Federal Register

Friday, June 11, 2010

[Docket No. FAA-2008-0071; Directorate Identifier 2006-SW-27-AD; Amendment 39-16291; AD 2010-10-12]

Airworthiness Directives; Bell Helicopter Textron Canada Model 222, 222B, 222U, 230, and 430 Helicopters

Figure 1

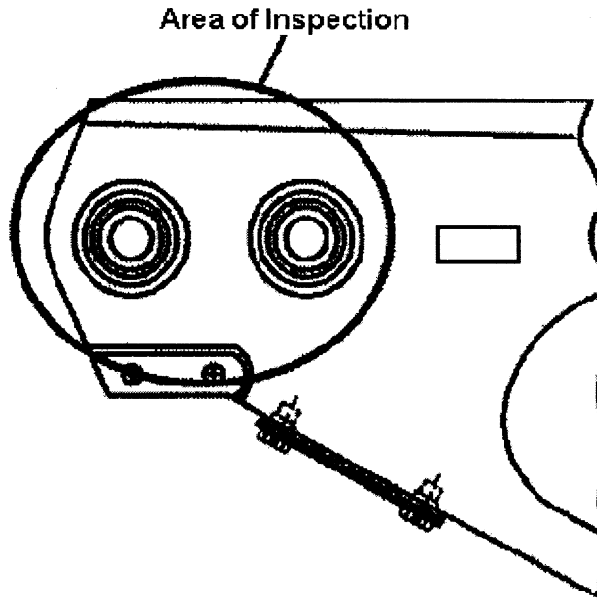
(a) Within 3 hours time-in-service (TIS), unless accomplished previously, and thereafter at intervals not to exceed 3 hours TIS, clean and visually check both sides of each blade for a crack in the paint in the areas shown in Figure

(c) Within the next 50 hours TIS, unless accomplished previously, and thereafter at intervals not to exceed 50 hours TIS, clean the blade by wiping down both surfaces of each blade in the inspection area depicted in Figure 1 of this AD using aliphatic naphtha (C-305) or detergent (C-318) or an equivalent. Using a 10X or higher power magnifying glass, visually inspect both sides of the blade in the areas depicted in Figure 1 of this AD.
